**SUNDRY NOTICES AND REPORTS ON WELLS**  
*Do not use this form for proposals to drill or to re-enter an abandoned well. Use Form 3160-3 (APD) for such proposals.*

### Tenneco Federal #1R

Re: Permanent Abandonment  
Well: Tenneco Federal #1R

CONDITIONS OF APPROVAL

## Proposed P&A

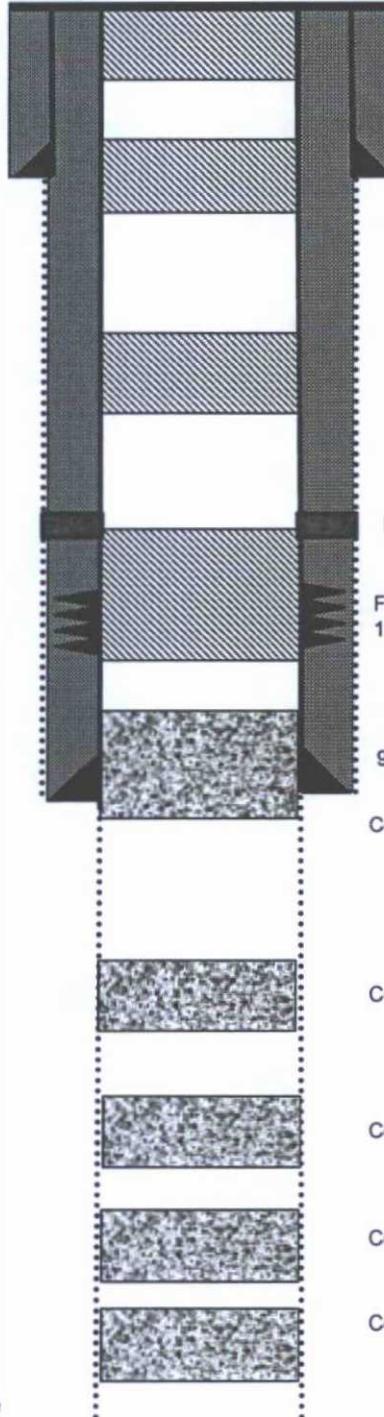
**Plug #4: 182' - 0'**  
Class B cement, 70 sxs

1. Plugging operations authorized are subject to the attached "General Requirements for Permanent Abandonment of Wells on Federal and Indian Lease."
2. Farmington Office is to be notified at least 24 hours before the plugging operations commence (505) 564-7750.
3. The following modifications to your plugging program are to be made:
  - a) Set plug #4 (259-0) ft. to cover the Kirtland top. BLM picks top of Kirtland at 209 ft.
